Comments from Geotechnical Engineering Office, Civil Engineering and Development Department

The Geotechnical Engineering Office has the following comments on the responses-to-comments (R-to-C) and the associated contents of the revised Geotechnical Planning Review Report (GPRR) for the captioned application.

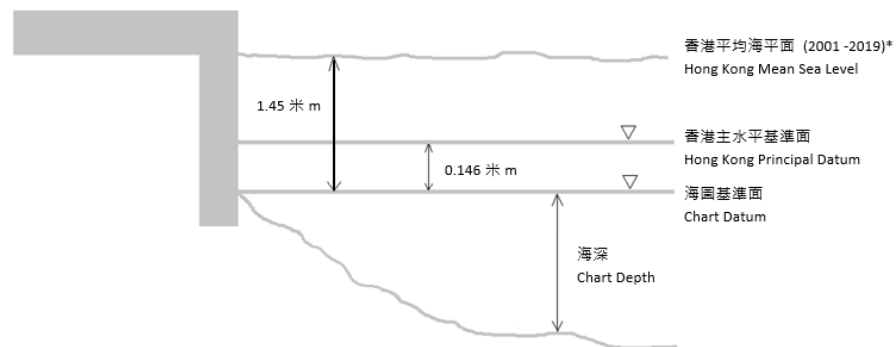
Please provide us with a brief record of relevant sea level references or historical tidal data from the Hong Kong Observatory at or near the application sites and elaborate on the design considerations / measures of the proposed installation to mitigate the potential flood risks to further justify the application.

To reply to this comment, we considered the maximum sea levels available from the public website of the Hong Kong Observatory for the Tai O station, which is the closest to the proposed location for the radar installation.

where the observations have been ranked from the highest to the lowest for 121 events.

For the sake of clarity we report here only the ten most highest water levels.
